TECHNICAL NOTE ACOUSTICS

DATE:	12 November 2024	CONFIDENTIALITY:	Public
SUBJECT:	Land South of Bedwell Road, Ugley - Approval of Reserved Matters Noise Comments		
PROJECT:	UK0033240.2467	AUTHOR:	Toby Lewis
CHECKED:	Robert Colder	APPROVED:	Toby Lewis

UDC EPO CONSULTATION RESPONSE

WSP RESPONSE

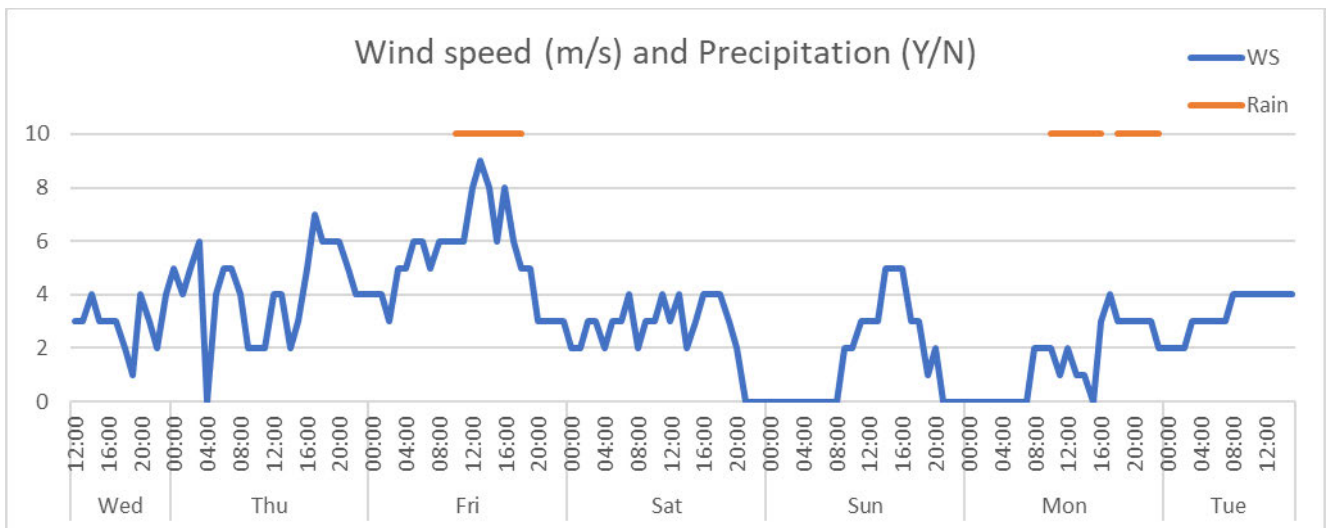
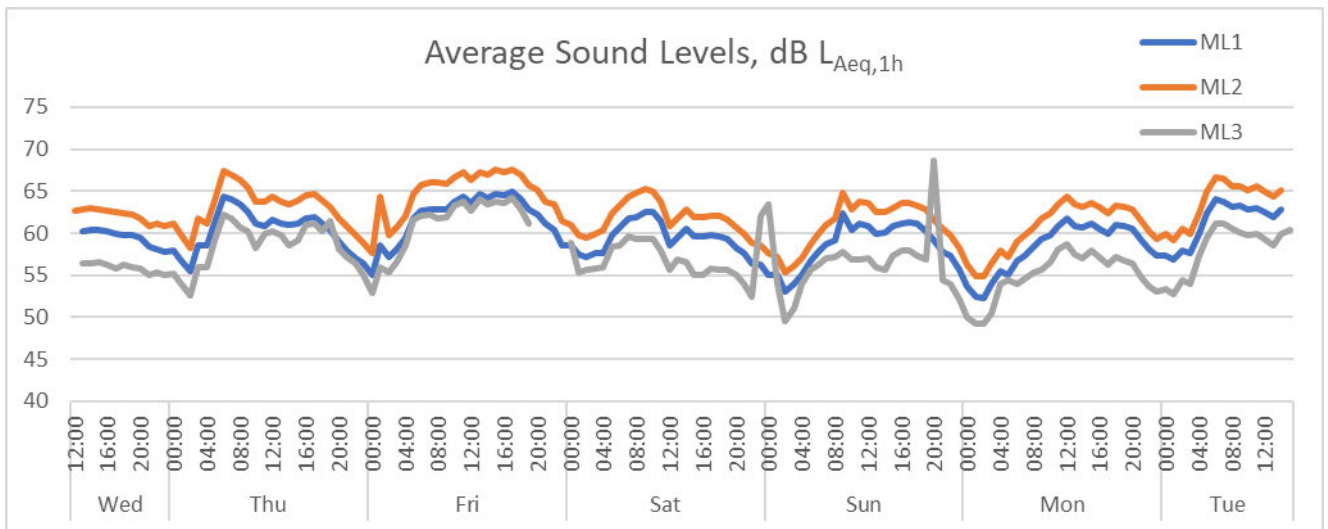
- 1) Confirmation with respect to data exclusions due to wind speed and precipitation during the WSP May 2024 noise survey.
- 2) A graph or table showing any sound level data excluded prior to analysis.
- 3) Detailed assessments of the internal night-time $L_{Aeq,8h}$ sound levels with windows closed.
- 4) Noise mitigation proposals for all of the proposed building facades.
- 5) Detailed break-in calculation sheets for a small selection of the calculations.

2) **Graph of monitoring data.** The first graph below shows the average sound levels (dB $L_{Aeq,1h}$) logged at each of the three monitoring locations used in the May 2024 survey. The second graph shows the average wind speed and periods of precipitation logged at the MET Office observation station at Andrewsfield (around 10 miles to the east of the application site).

It is credible that the higher windspeeds and rainfall evident on the Friday (03 May 2024) led to slightly higher sound levels being logged than would otherwise be the case. However, the retention of these data during analysis could only have led to slightly elevated sound levels which would, in these circumstances, contribute to a precautionary assessment. For that reason, the removal of potentially weather affected data was considered unnecessary.
